STATE OF MAINE  
DEPARTMENT OF TRANSPORTATION  
16 STATE HOUSE STATION  
AUGUSTA, MAINE 04333-0016

March 23, 2026  
Subject: Farnham & Osborn  
Bridge Replacement  
WIN: 026109.00, 026111.00  
Location: **Pittsfield**  
**Amendment No. 2**

STATE OF MAINE DEPARTMENT OF TRANSPORTATION	02610900 & 02611100 WIN 26109.00 & 26111.00 BRIDGE NO. 2274 & 2634
FARNHAM AND OSBORNE BRIDGE FARNHAM BROOK SOMERSET COUNTY PITTSFIELD	ESTIMATED QUANTITIES AND GENERAL CONSTRUCTION NOTES
SHEET NUMBER  <b>2</b> OF 40	BRIDGE PLANS

OSBORNE BRIDGE  
FARNHAM BROOK  
SOMERSET COUNTY  
PITTSFIELD  
PRECAST CONCRETE  
BOX DETAILS 1

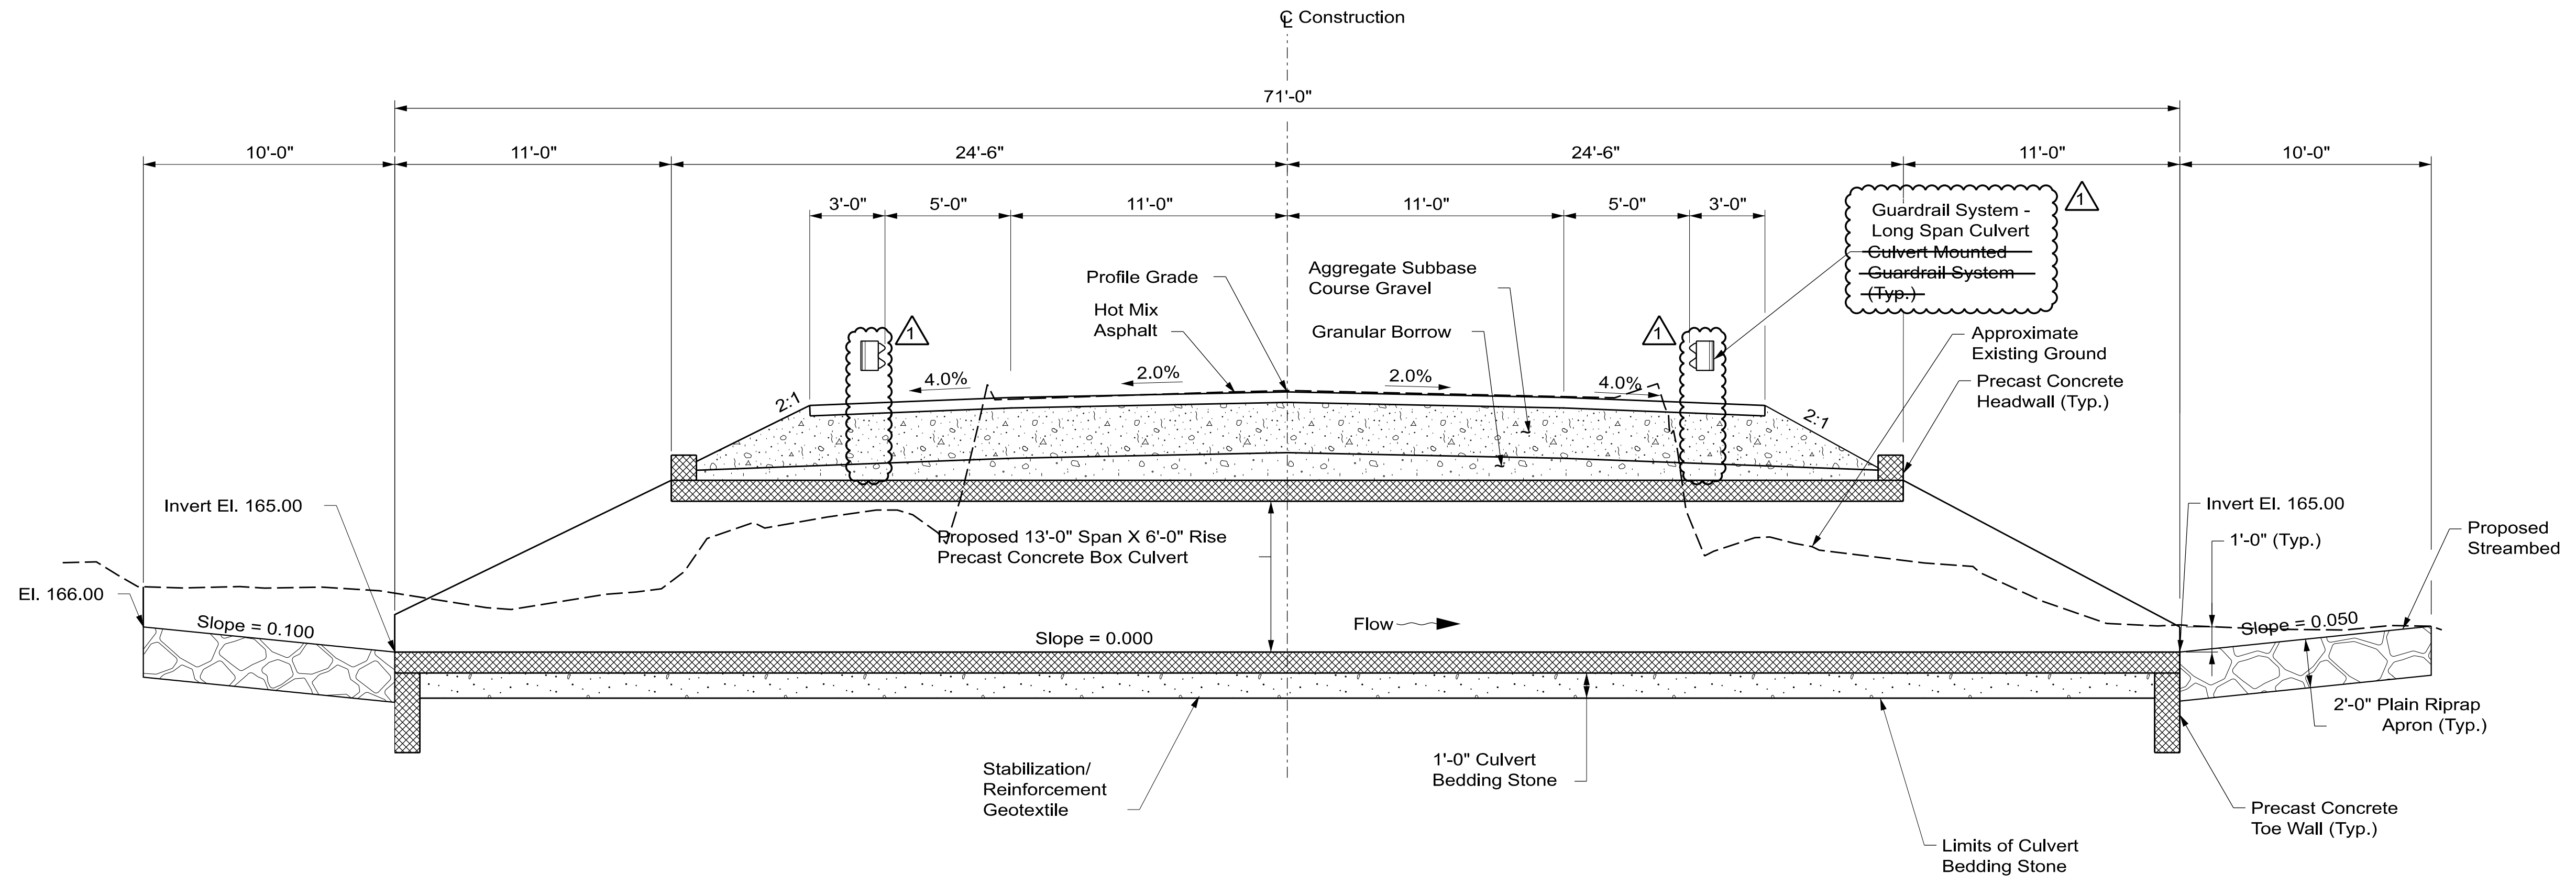
**REMOVE** Sheet No. 18, PRECAST CONCRETE BOX DETAILS 1 dated February 6, 2026 (1 sheet) and **REPLACE** with Sheet No. 18, PRECAST CONCRETE BOX DETAILS 1 dated March 19, 2026 (1 sheet)

PROJ. MANAGER	BY	DATE
DESIGN-DETAILED	B. NICHOLS	02/17/26
CHECKED-REVIEWED	M. SMITH	02/17/26
DESIGN-DETAILED	D. MUNRO	02/17/26
DESIGN-DETAILED	S. BEALMONT	02/17/26
DESIGN-DETAILED	A. YONAKKA	02/17/26
DESIGN-DETAILED	M. BRENZ	02/17/26
REVISIONS 1	CHANGE GUARDRAIL OVER CULVERT	02/20/26
REVISIONS 2		
REVISIONS 3		
REVISIONS 4		
FIELD CHANGES

OSBORNE BRIDGE FARNHAM BROOK PITTSFIELD SOMERSET COUNTY	GUARDRAIL SYSTEM - LONG SPAN CULVERT DETAILS
--	---

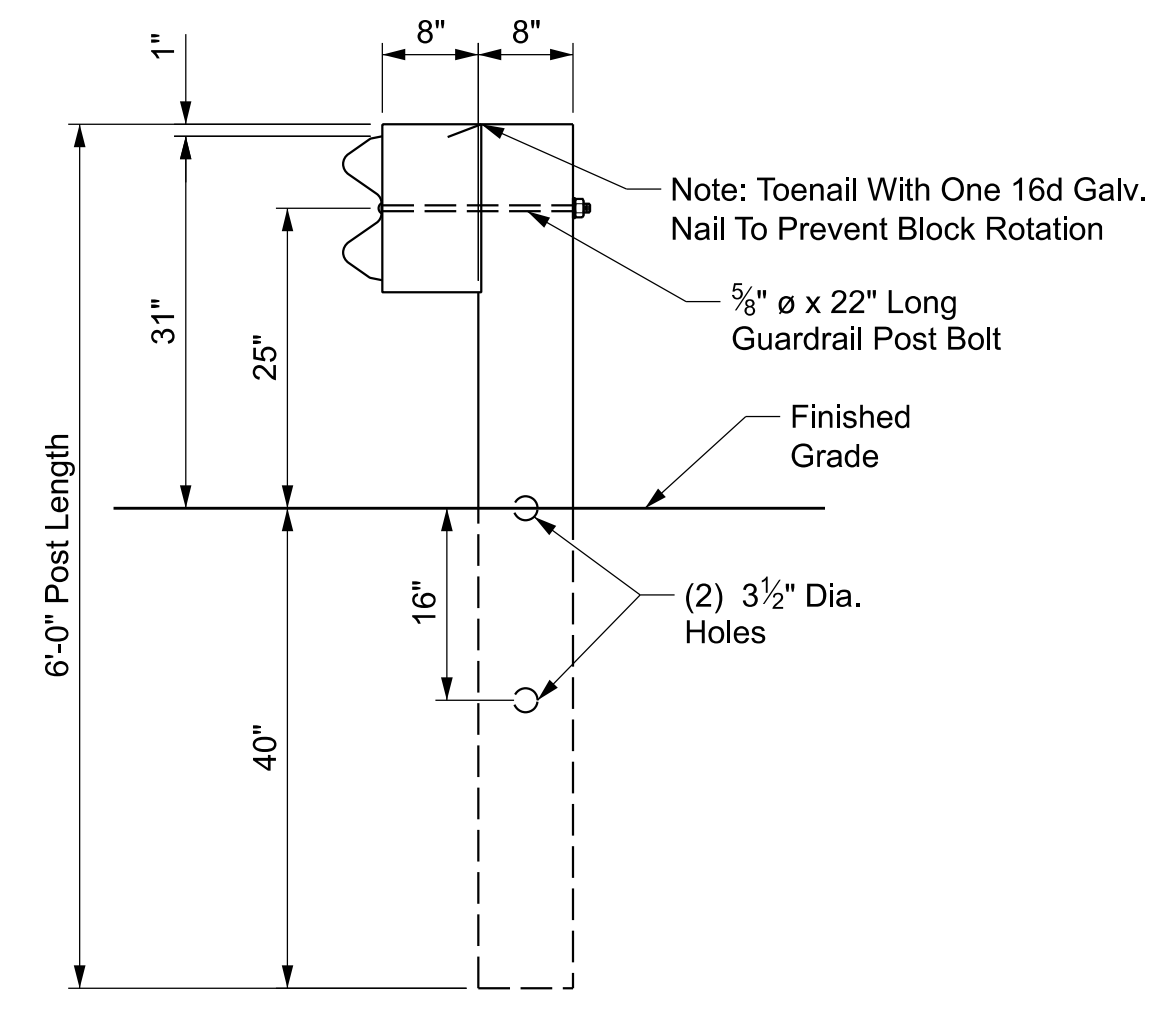
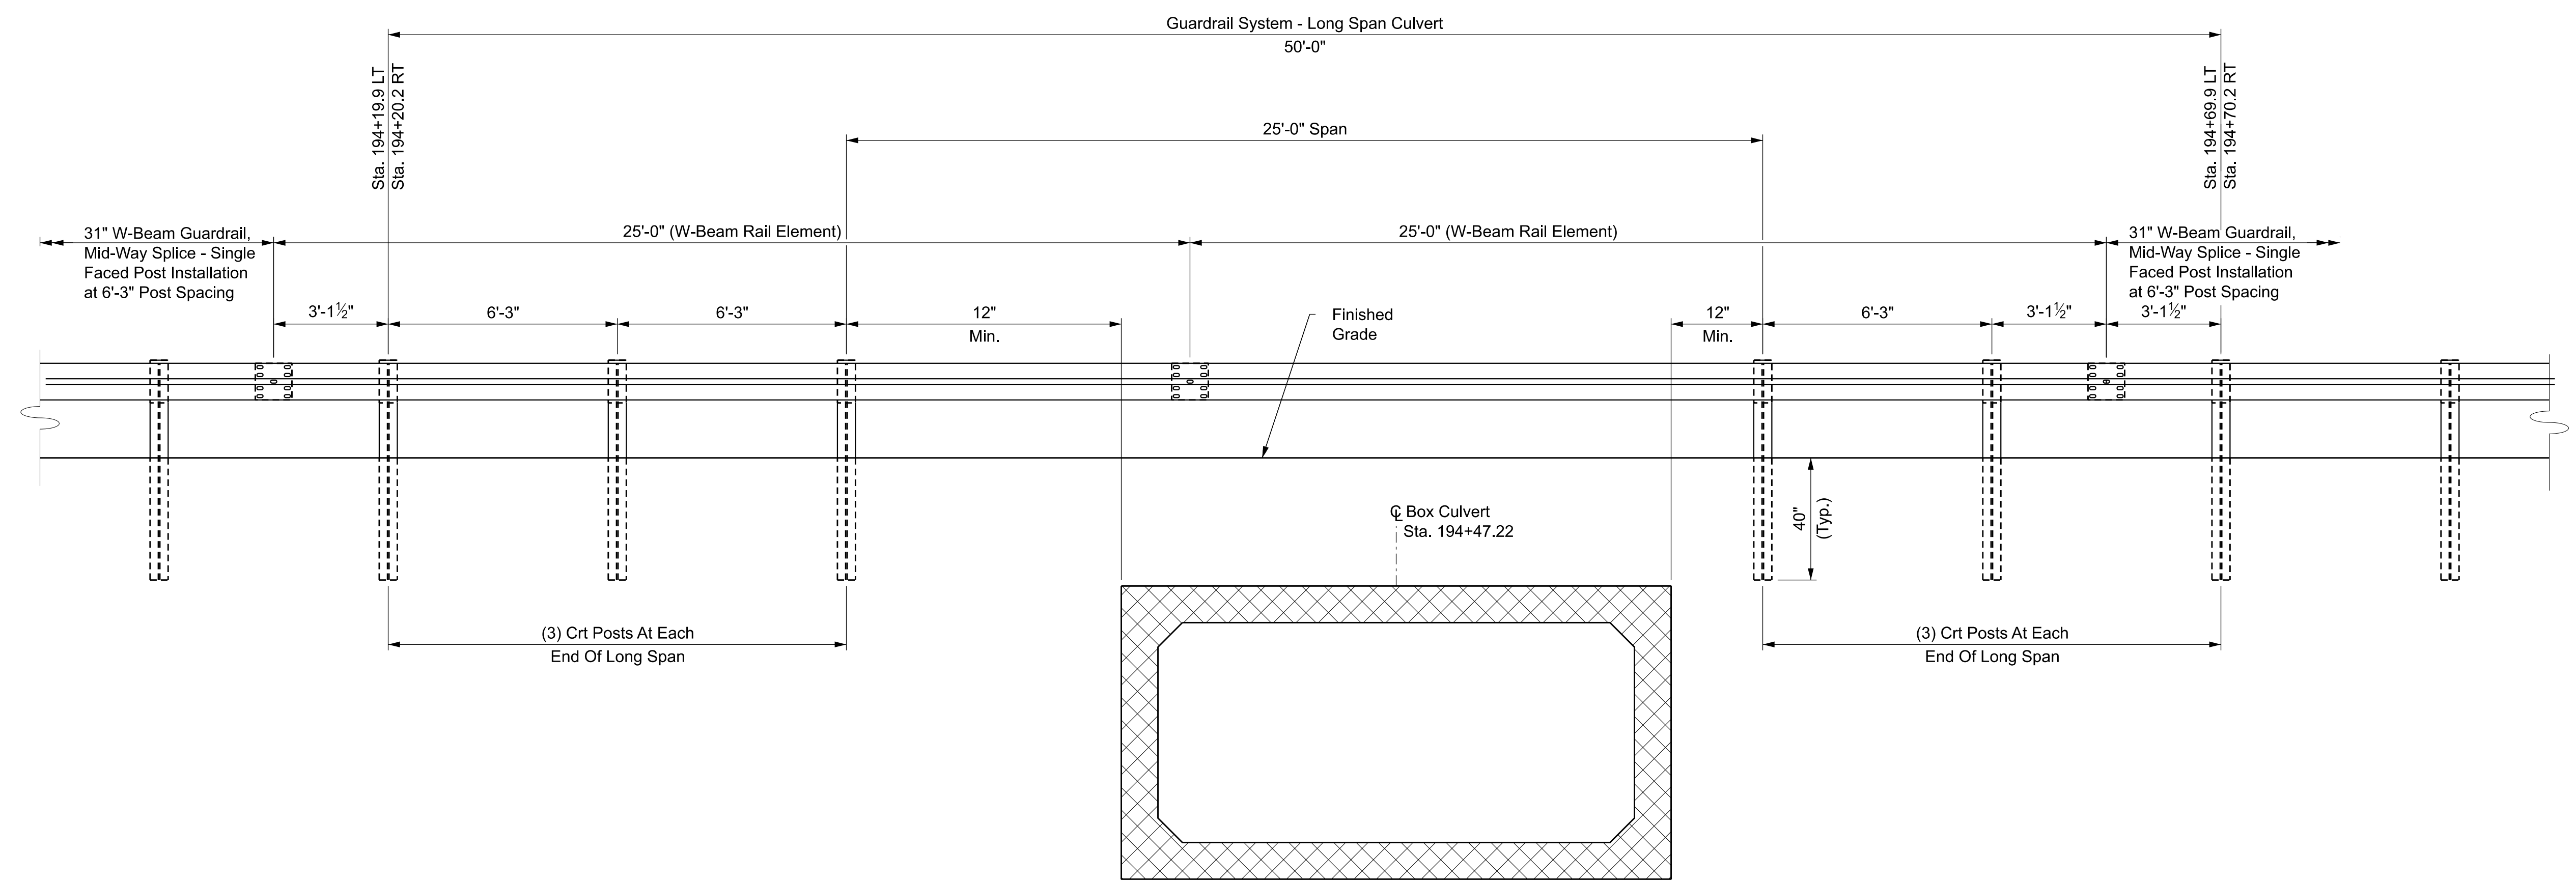
**REMOVE** Sheet No. 20, CULVERT MOUNTED GUARDRAIL SYSTEM DETAILS 1 dated February 6, 2026 (1 sheet) and **REPLACE** with Sheet No. 20, GUARDRAIL SYSTEM – LONG SPAN CULVERT DETAILS dated March 19, 2026 (1 sheet)

PROJ. MANAGER	BY	DATE
DESIGN-DETAILED	J. BRICE	03/20/26
CHECKED-REVIEWED	S. BEALMONT	03/20/26
DESIGN-DETAILED	A. YONAKA	03/20/26
DESIGN-DETAILED	M. BRENZ	3/20/26
REVISIONS 1	Change Guardrail over Culvert	
REVISIONS 2		
REVISIONS 3		
REVISIONS 4		
FIELD CHANGES

1. Rail element shall meet all requirements of item 616.1301 "W-Beam Guardrail, Mid-Way Splice - Single Faced. The Contractor may furnish rail elements of 12'-6" or 25'-0" nominal lengths.
2. Posts shall not be set in concrete, of any depth.

(6) CRT Post Required  
See Elevation Detail  
for Locations

**ELEVATION DETAIL  
LONG SPAN GUARDRAIL**

OSBORNE BRIDGE  
FARNHAM BROOK  
SOMERSET COUNTY  
PITTSFIELD  
CROSS SECTIONS

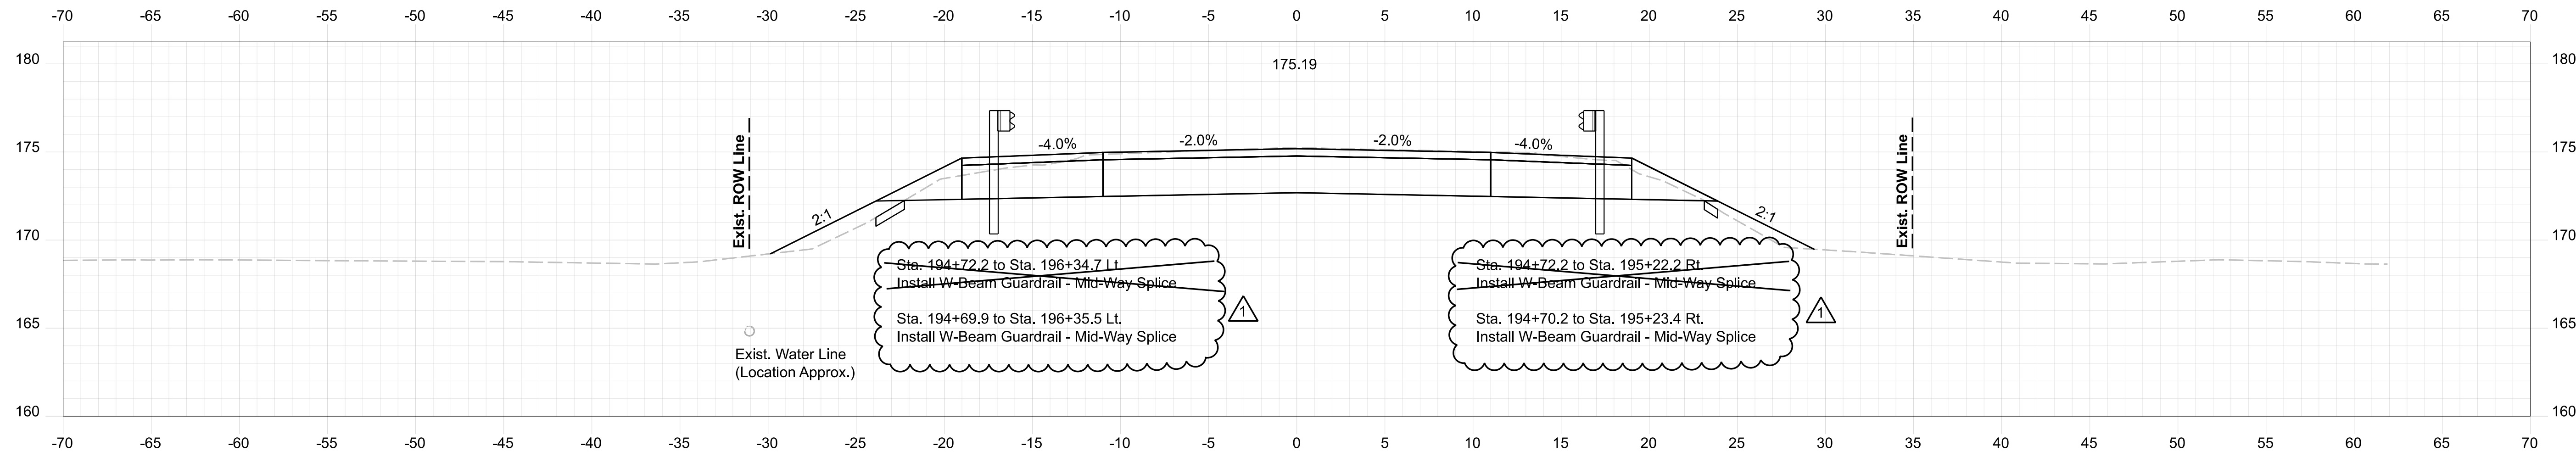
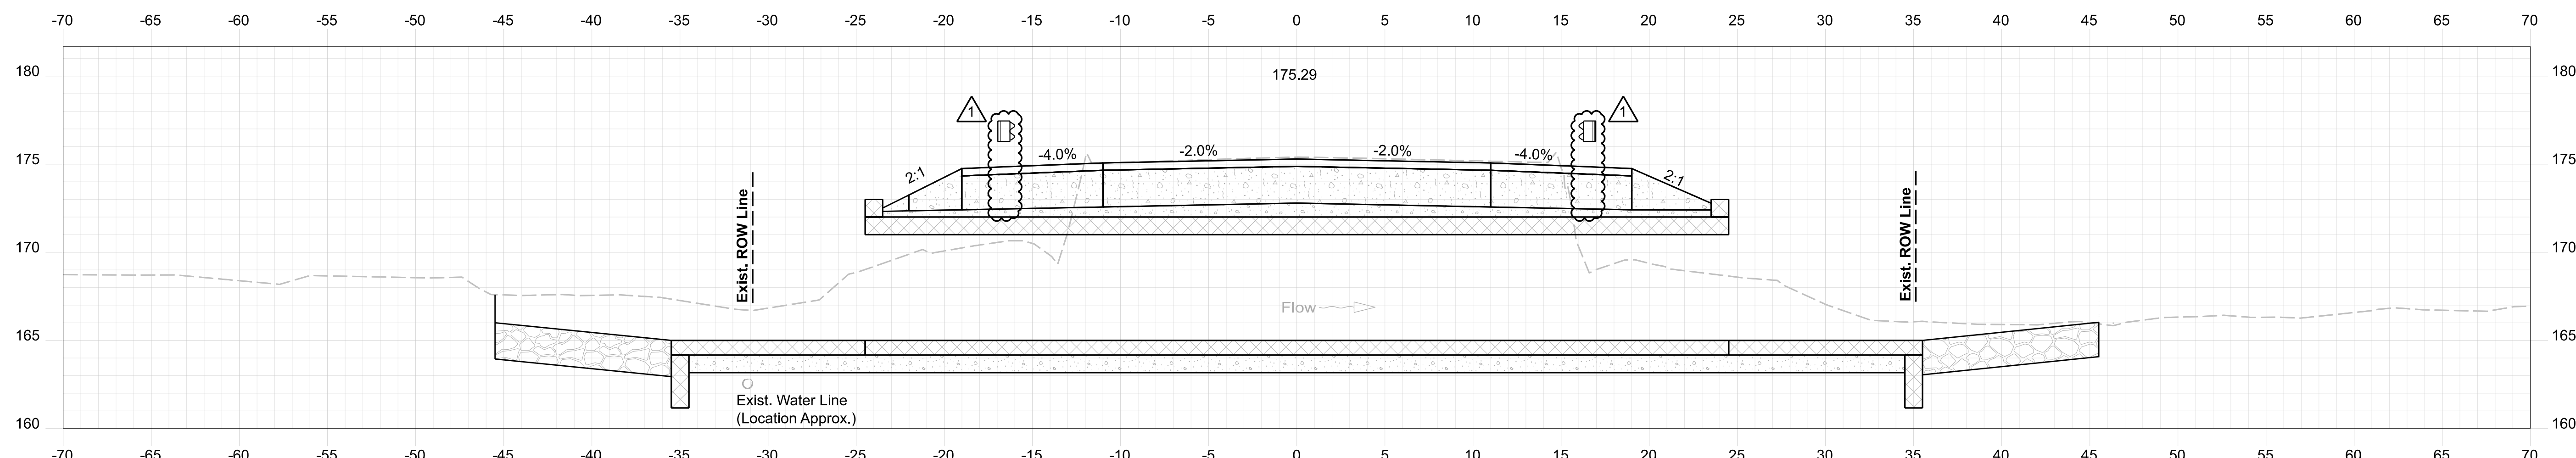
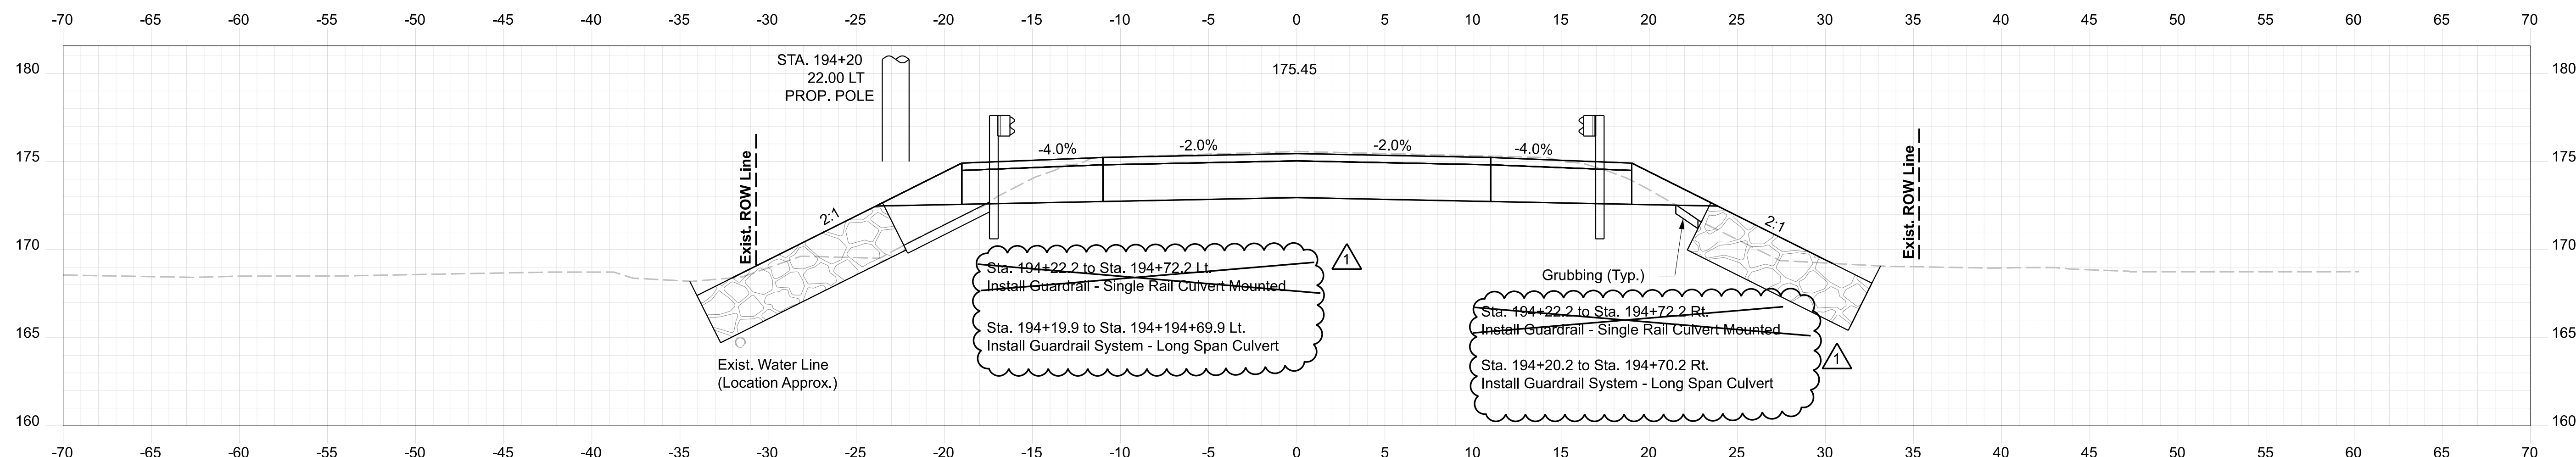
**REMOVE** Sheet Nos. 30, 32-34, CROSS SECTIONS dated February 6, 2026 (4 sheets) and  
**REPLACE** with Sheet Nos. 30, 32-34, CROSS SECTIONS dated March 19, 2026 (4 sheets)

PROJ. MANAGER	BY	DATE
B. NICHOLS	M. SMITH	02/17/26
J. BRICE	D. MUNRO	02/17/26
S. BEALMONT	A. YONAKA	02/17/26
M. BRAZ		
REVISIONS 1	CHANGE GUARDRAIL OVER CULVERT	03/20/26
REVISIONS 2		
REVISIONS 3		
REVISIONS 4		
FIELD CHANGES
